City of Aurora Building Division
 Project: **Davita Tenant Improvement**
 Address: **1411 S. Potomac St. # 100**
 Occupancy Group: **B**
 Construction Type: **II 1hr-SPK.**
 RSN: **1322345**
 Permit: **18-1529237 LT**

City of Aurora Building Division
 Reviewed for Code Compliance
 Approved as Noted: **pmckown**
 Date: **Sep 26, 2018**
 2015 INTERNATIONAL CODES & 2017 NEC

Davita
 Aurora Dialysis Center Upgrades
 at
 1411 South Potomac Street, Suite 100
 Aurora, Colorado 80012

SHEET NO.
E-2

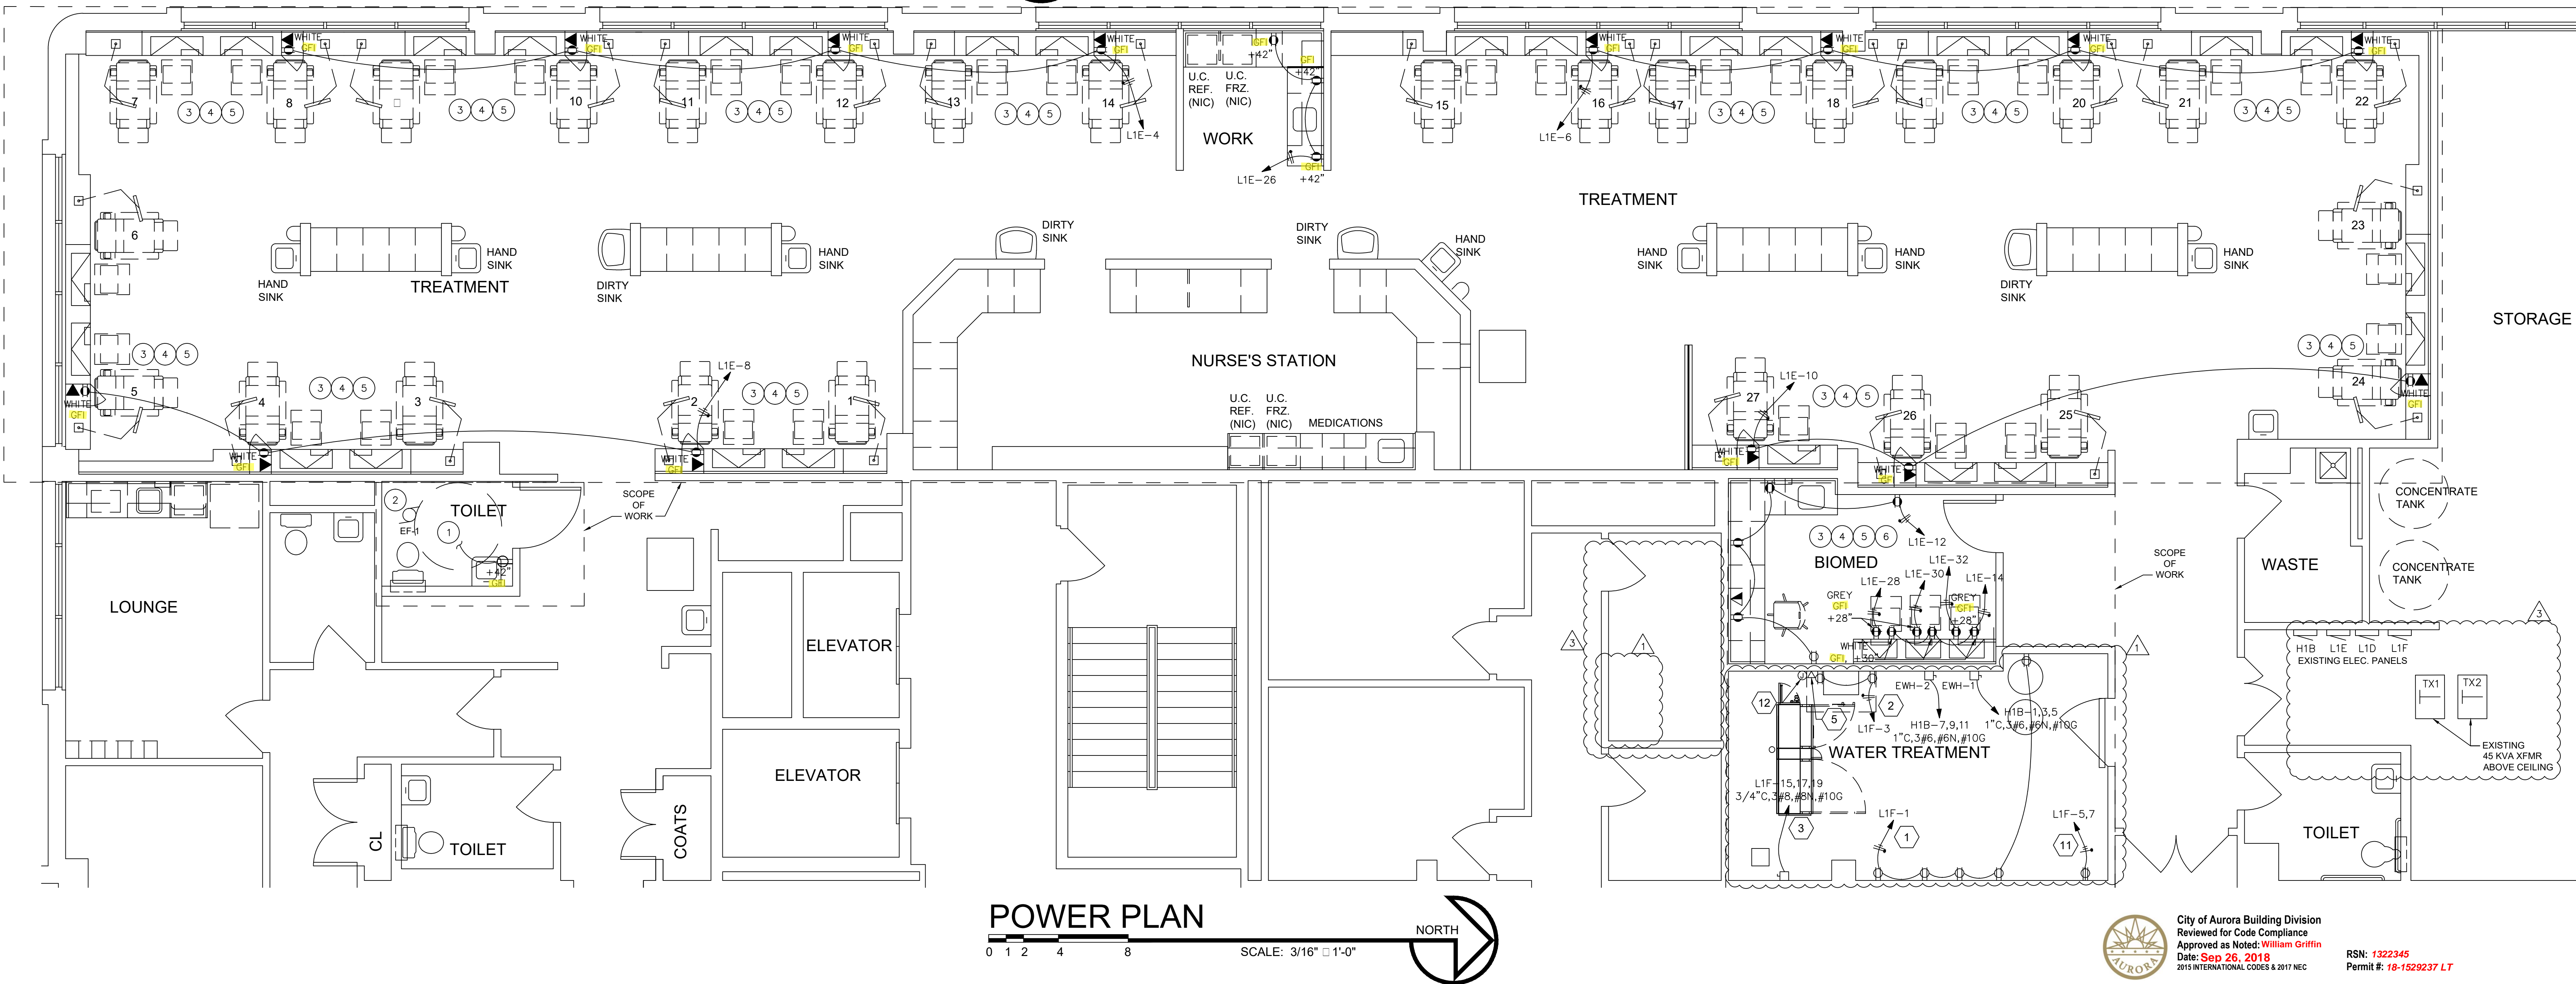
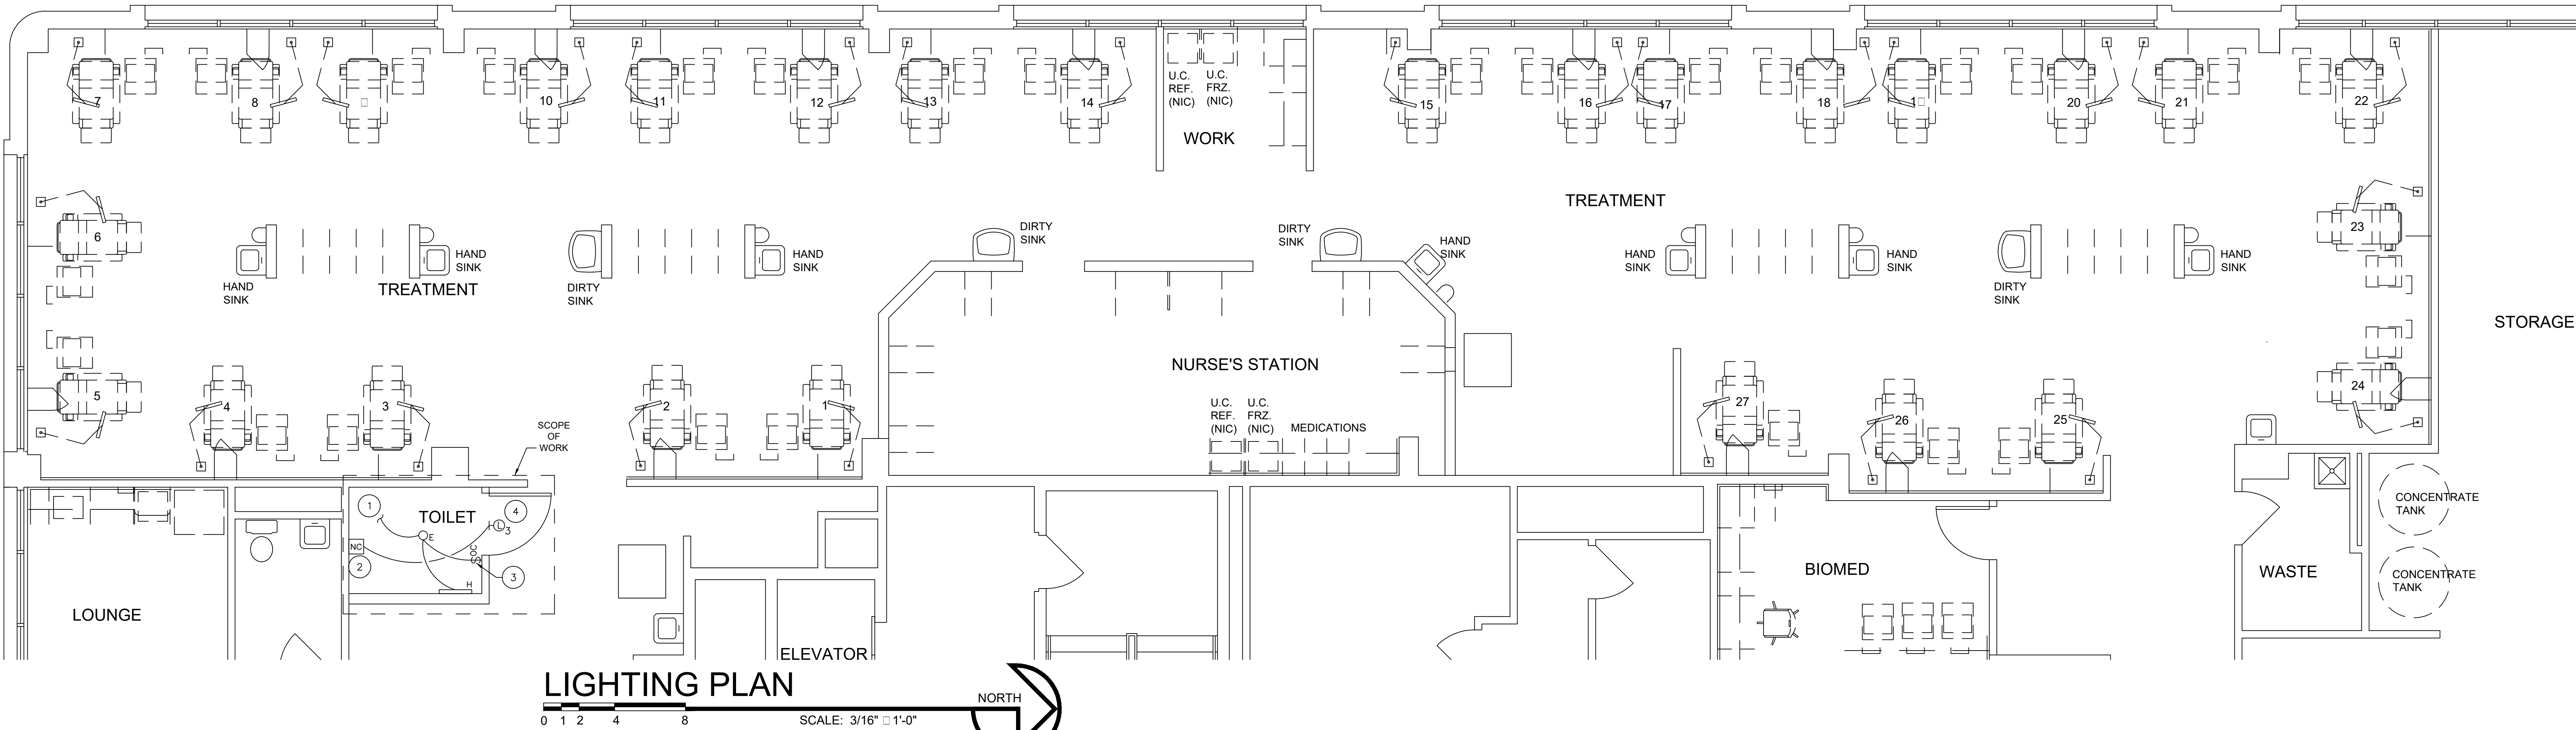
Install electrical connections per 2017 NEC 110.14, identify disconnects per 2017 NEC 110.22 and provide working space around electrical equipment per 2017 NEC 110.26.

Wiring in air handling spaces must comply with 2017 NEC 300.22. Firestop penetrations per 2017 NEC 300.21. Secure and support equipment per 2017 NEC 300.11.

Locate the required overcurrent protection per 2017 NEC 240.21

1 EXISTING - ONE-LINE DIAGRAM

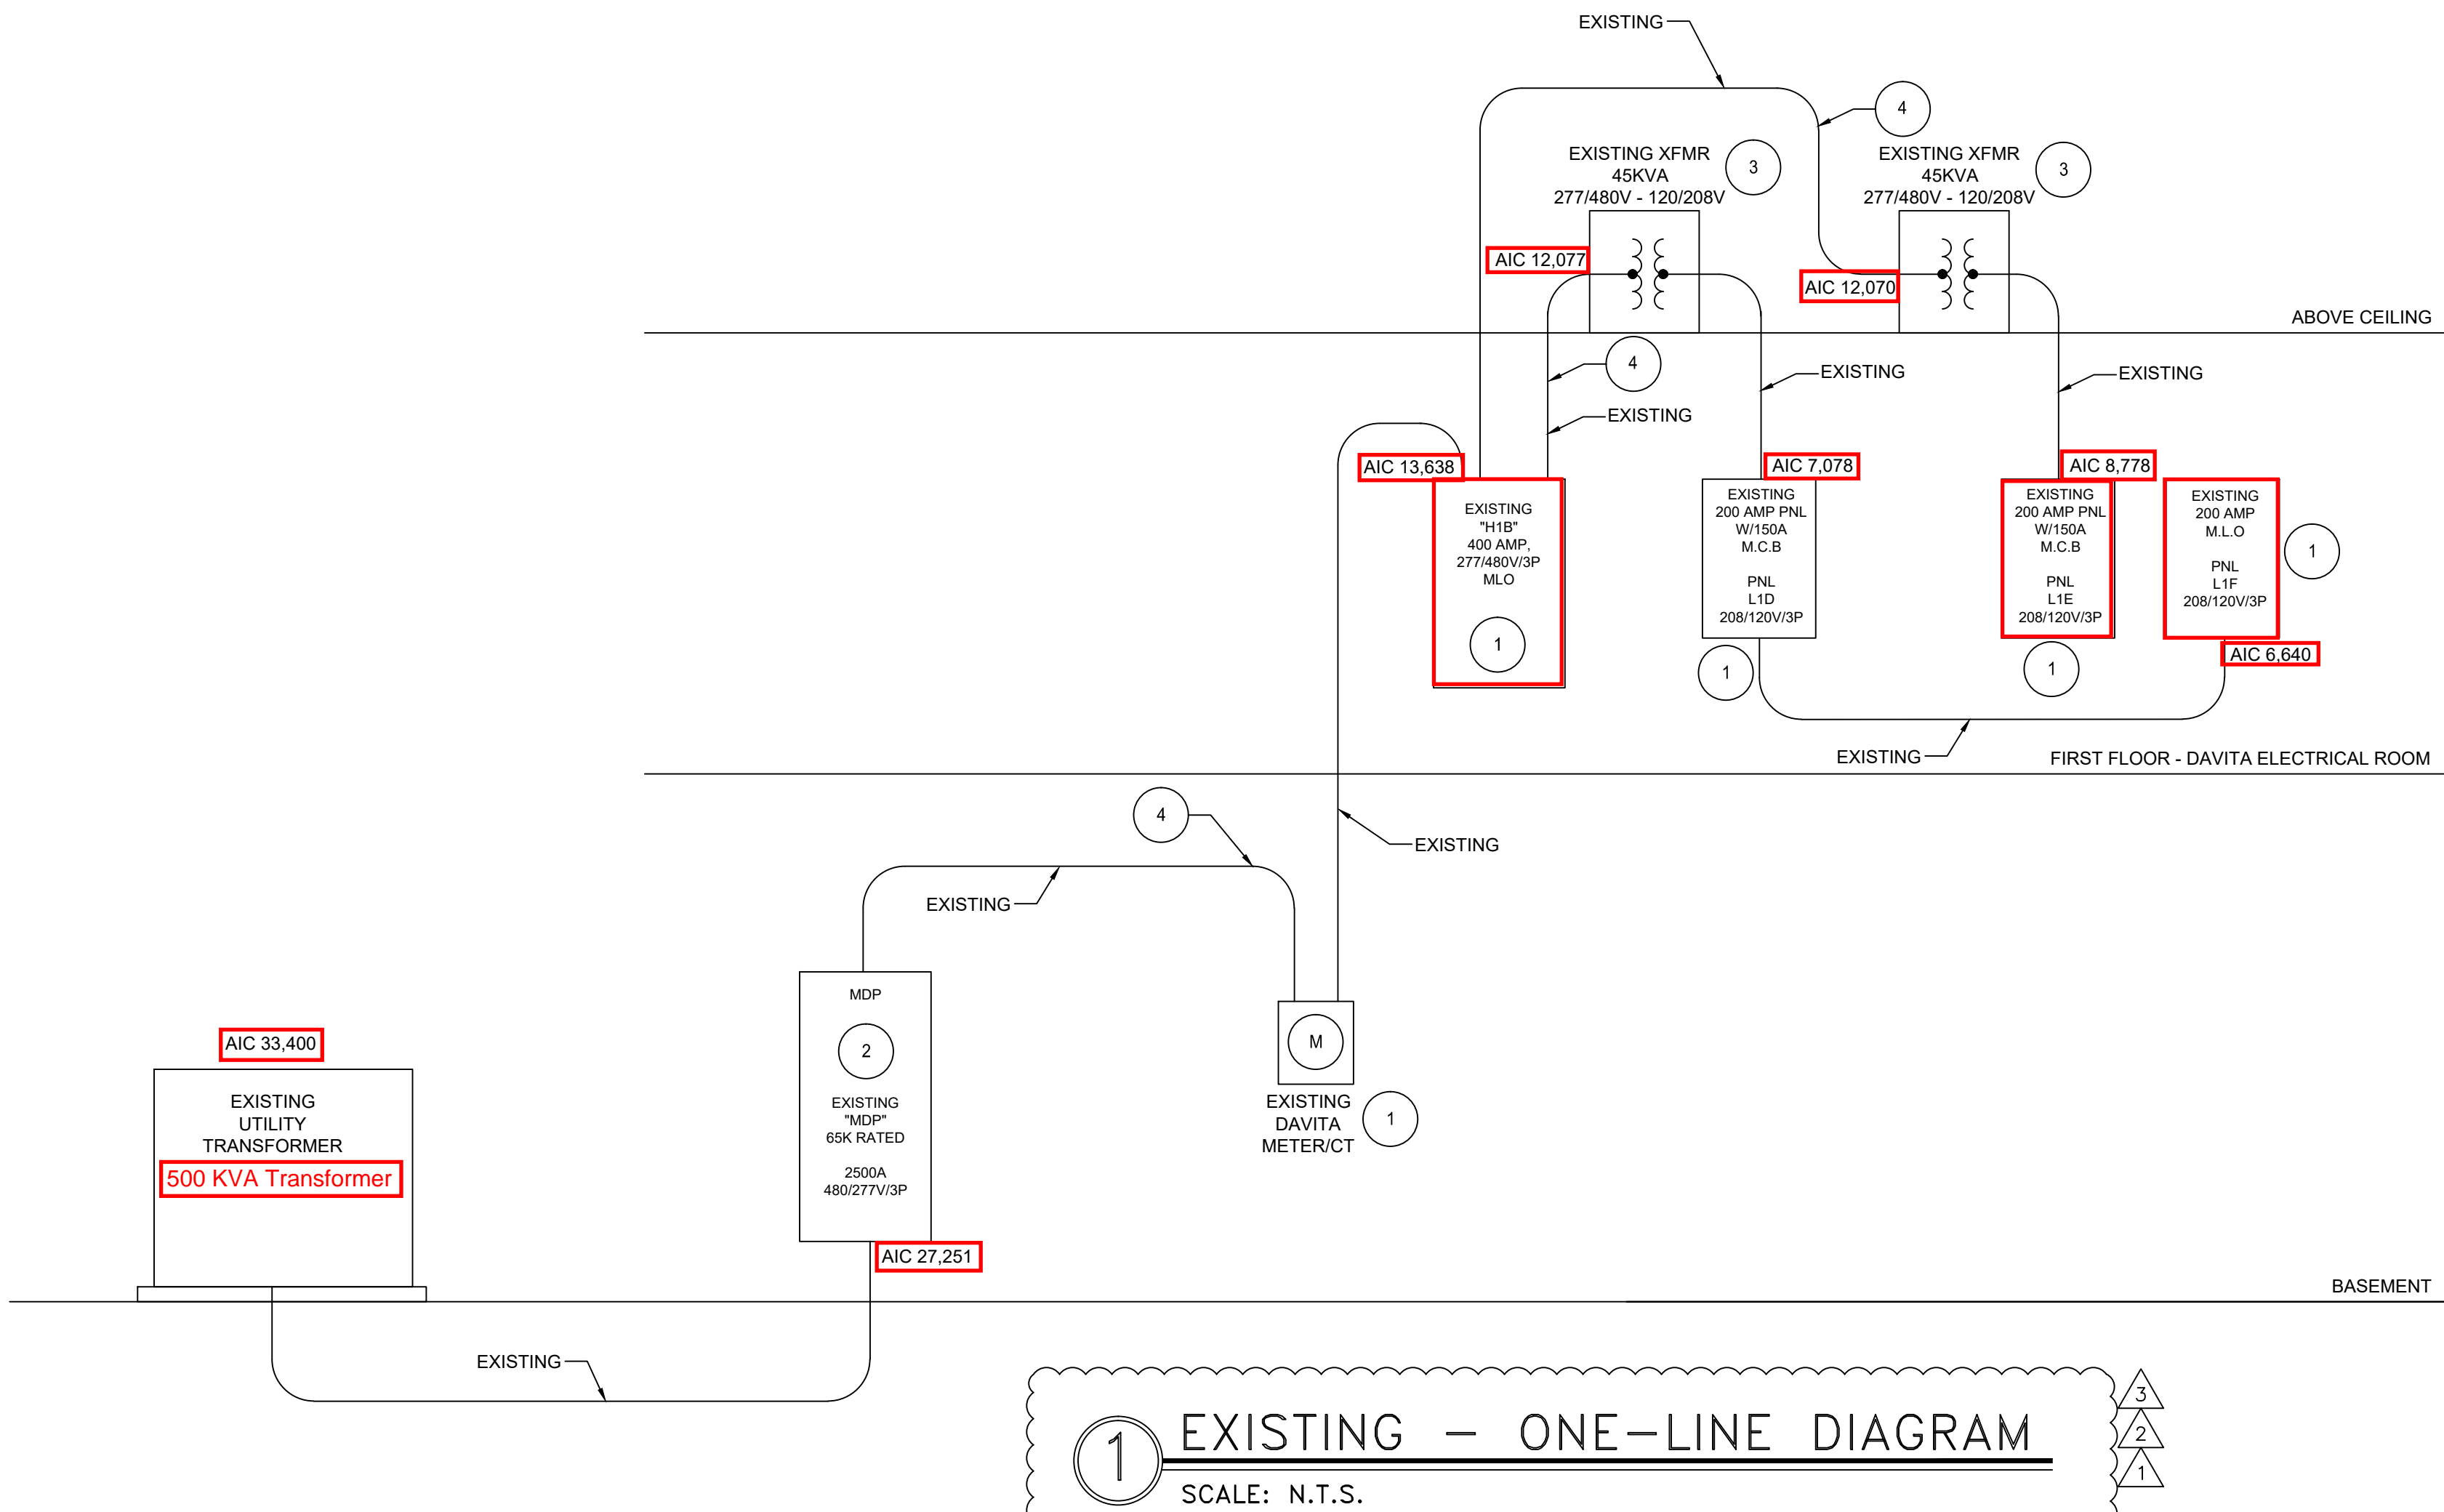
Legibly identify each breaker or switch for it's use or purpose on the circuit directory in the panel/switchboard per 2017 NEC 408.4.

Service equipment shall be permanently and legibly marked to show the available fault current and date. 2017 NEC Article 110.24(A)(B).
